Revisions to Chapter 3, “Project Alternatives”

Chapter 3 of this document (the Draft SEIS/REIR) is being revised in response to public comments received on the Draft EIS/EIR (Jones & Stokes 2003). The majority of these changes would not change the text in such a way as to require recirculation for public comment. However, the U.S. Department of the Interior, Bureau of Reclamation (Reclamation) and the State Water Resources Control Board (State Water Board) have deemed that the following changes to this chapter constitute significant new information. As a result, the lead agencies have included these changes here for public disclosure and comment. The complete revised chapter will be presented in the Final EIS/EIR.

Figure 3-2c
Proposed Facilities for the Inskip Diversion Dam/South Powerhouse
Five Dam Removal Alternative

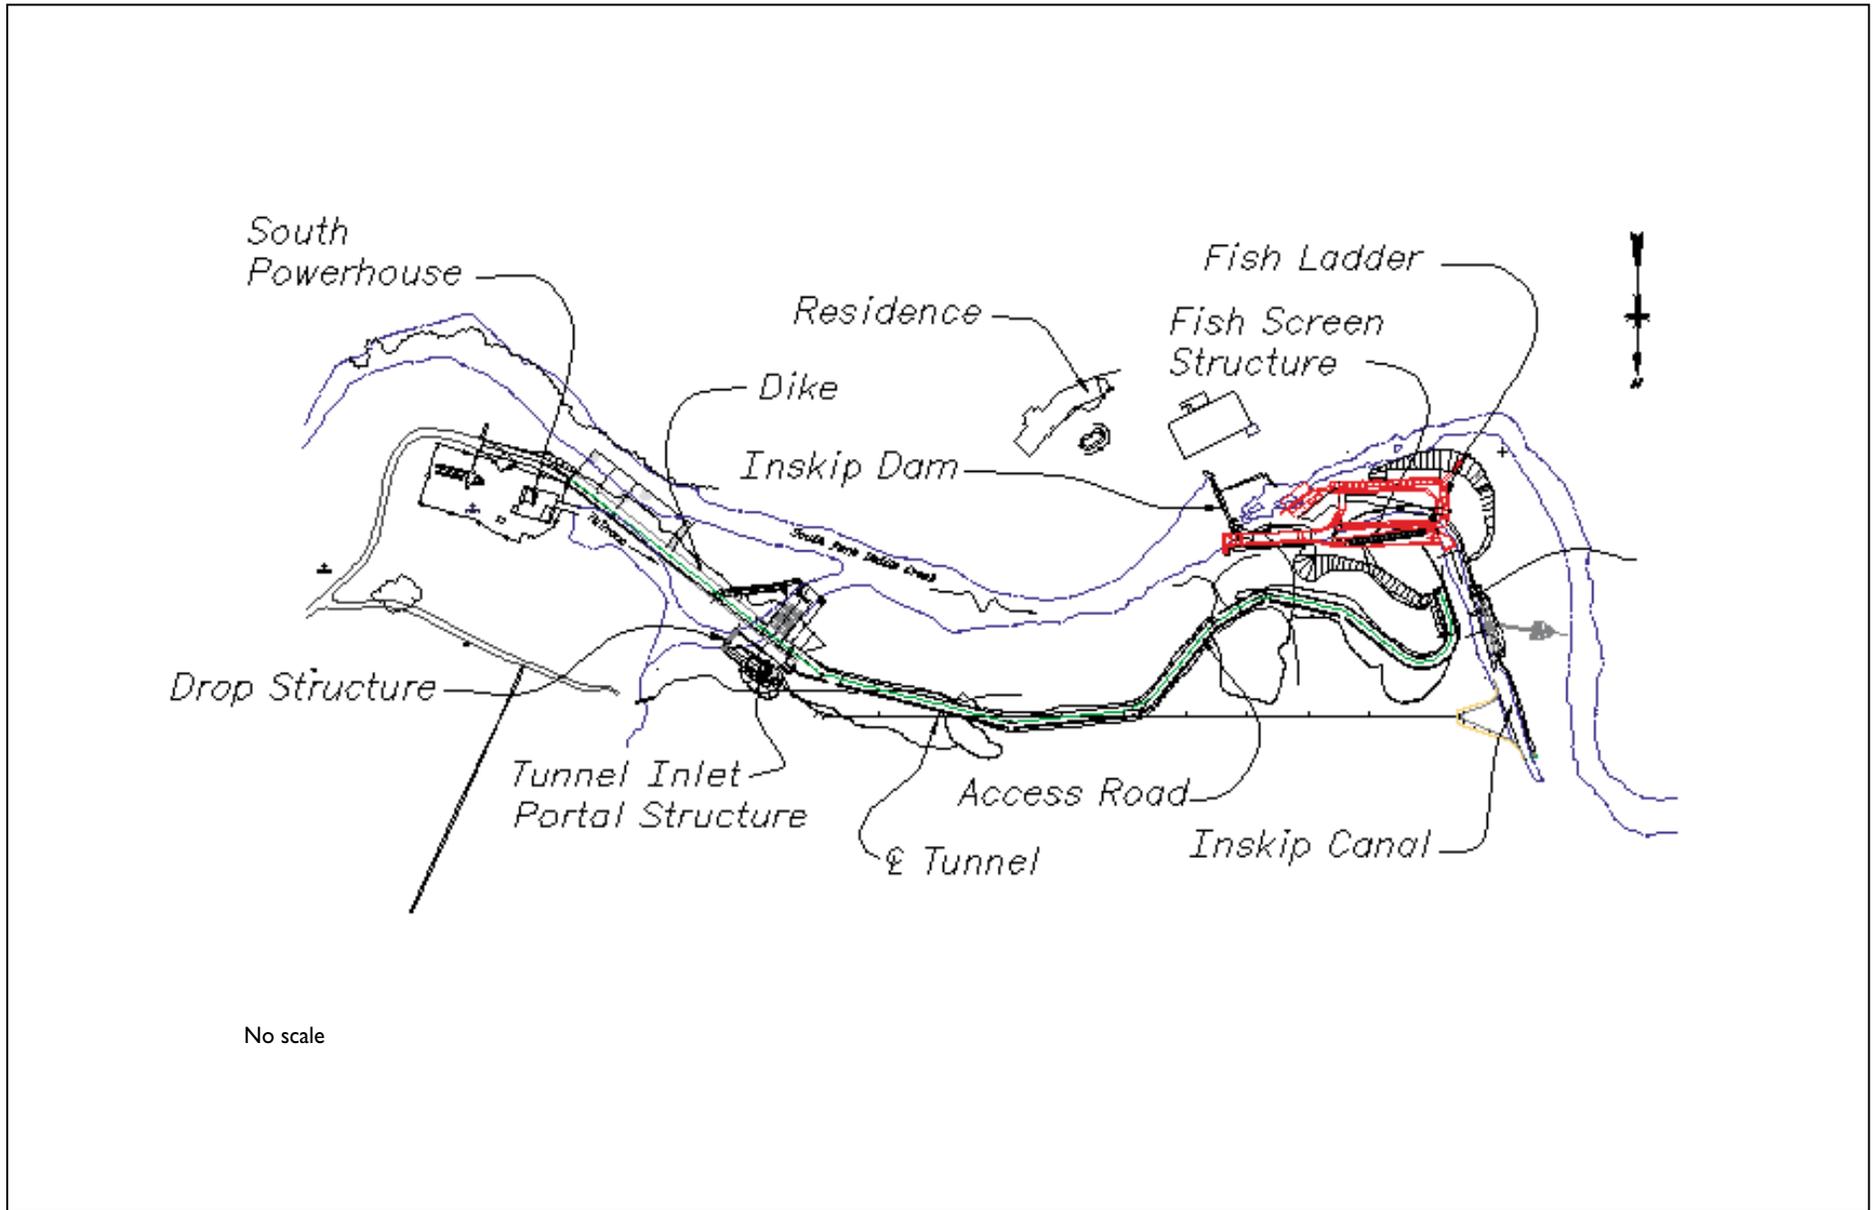
Proposed New Access Road between South Powerhouse and Inskip Diversion Dam. Permanent vehicular access would be required to construct, operate, and maintain the proposed Inskip Diversion Dam fish screen and ladder and new tunnel outlet portal facilities. The new road would begin at the South Powerhouse and use the tailrace dike to cross the tailrace area. The road would then travel overland from a point near the tunnel inlet portal toward Inskip Diversion Dam fish screen and ladder facilities on the north side of South Fork Battle Creek. The proposed road alignment is shown on Figure 3-2c.

After crossing the tailrace channel via the tailrace dike, the 1,850-foot-long road would rise above the riparian vegetation zone and existing foot trail and then roughly parallel the slope to the vicinity of Inskip Diversion Dam. Construction of this section of the access road would require a 16-foot-wide cut with the upslope side of the road cut at a slope of 1½:1. The maximum cut in the slope would be 31 feet high. As the road approaches Inskip Diversion Dam, the road begins dropping to the level of the fish screen and ladder, where a large, flat

staging/parking area would be developed. This staging/parking area would be roughly 60 feet by 70 feet in size. This sloped area would be cleared and flattened to provide both construction access and long-term operation and maintenance staging. An additional spur road would be developed off the staging/parking area that parallels Inskip Canal along its upslope side to the bypass tunnel outlet portal area.

The proposed road would be 12 feet wide, with two turnouts (at the hill crest and curve) and an additional 4 feet of width to provide for hillside drainage and guardrails as required. The road would be designed to provide all-weather access to the various sites for operation and maintenance purposes. The entire length of the road would be provided with 6-inch gravel surfacing, and those portions of the road with slopes greater than 6% would be topped with a 3-inch-thick asphalt layer. A maximum grade of 12% was assumed in accordance with safety standards. A minimum radius curvature of 50 feet at centerline was assumed sufficient for concrete mixer-truck travel during construction.

Construction of the proposed access road would also require relocating one power pole and associated power line. This pole would be relocated upslope of the proposed road near its current location; the new site would be chosen to avoid impacts on trees and facilitate any needed rewiring.
